Access Compliance Report

Public Rights-of-Way

Intersection ID: 32099	Main Street: STEELE_CREEK_RD	Cross Street: ROTHE_HOUSE_RD	Location: SW
ADA ID: 10C7D79DC2AD	Ramp Type: PerpDiag	Initial Pass/Fail: Fail	Overall Compliance: No
		Severity Score: 25

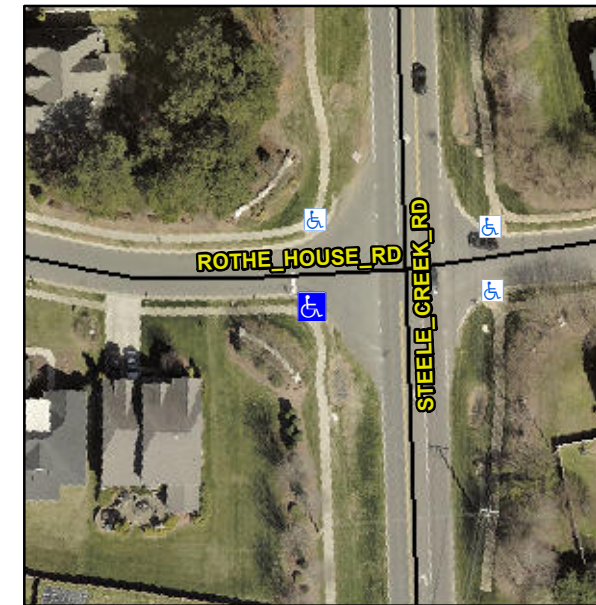
Not Found, R304.2.2

Compliance	Description	Data	Compliance	Description	Data
N/A	Ramp Length (in)	45.5	No	Ramp Slope (%)	14.6
Yes	Ramp Width (in)	48.0	Yes	Ramp XSlope (%)	0.9
N/A	Flare Type LT	N/A	N/A	Flare Type RT	N/A
N/A	Flare Slope LT (%)	N/A	N/A	Flare Slope RT (%)	N/A
N/A	Flare Traversable LT?	N/A	N/A	Flare Traversable RT?	N/A
N/A	Landing Length (in)	N/A	N/A	DWS Provided?	N/A
N/A	Landing Width (in)	N/A	N/A	DWS Contrast?	N/A
N/A	Landing Slope (%)	N/A	N/A	DWS Length (in)	N/A
N/A	Landing X Slope (%)	N/A	N/A	DWS Full Width?	N/A
N/A	Landing Curb? (Y/N)	N/A	N/A	DWS Offset (in)	N/A
N/A	Shared Landing?	N/A			
N/A	Gutter Ponding?	N/A	N/A	Gutter Slope (%)	N/A
N/A	Gutter Lip Ht (in)	N/A	N/A	Gutter X Slope (%)	N/A
N/A	Painted X Walk1?	No	N/A	Painted X Walk2?	No
	X Walk 1 Direction	To E		X Walk 2 Direction	To N
N/A	X Walk 1 Width (in)	N/A	N/A	X Walk 2 Width (in)	N/A
	X Walk 1 Slope (%)	1.7		X Walk 2 Slope (%)	3.4
	X Walk 1 X Slope (%)	2.2		X Walk 2 X Slope (%)	2.5

Remove & Replace Curb Ramp With Two New Directional Ramps or Equivalent.
